**SUBJECT : Hyundai ImageQuest Co., Ltd.**  
**FCC ID: PJIL19A00000**  
**Class II Permissive Change**  
**Orig. Grant Date : March 29, 2005**

Transmitted herewith, on behalf of Hyundai ImageQuest Co., Ltd. is an application for a Class II Permissive Change Certification of the following 19-inch LCD Monitor:

**FCC ID : PJIL19A00000**  
**Type No. : L19A00000**

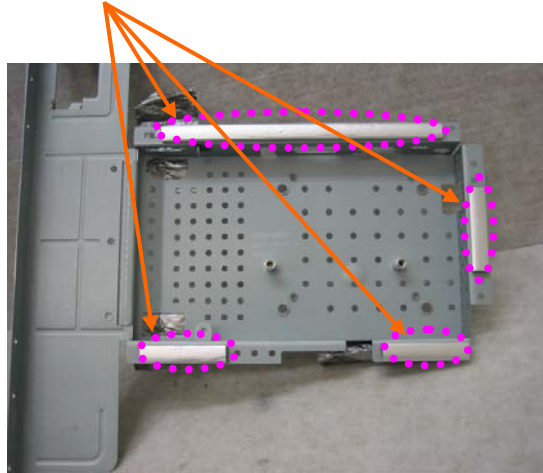
1. Attach a gasket on the main frame to contact the lcd panel

2. Attach a gasket on the main board to contact the main frame

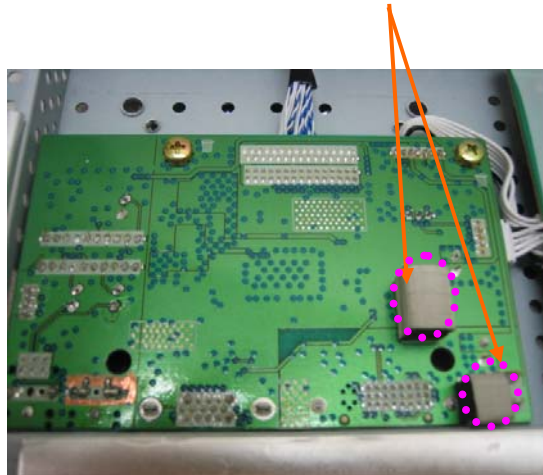
3. Attach aluminum tape on the Rear frame.
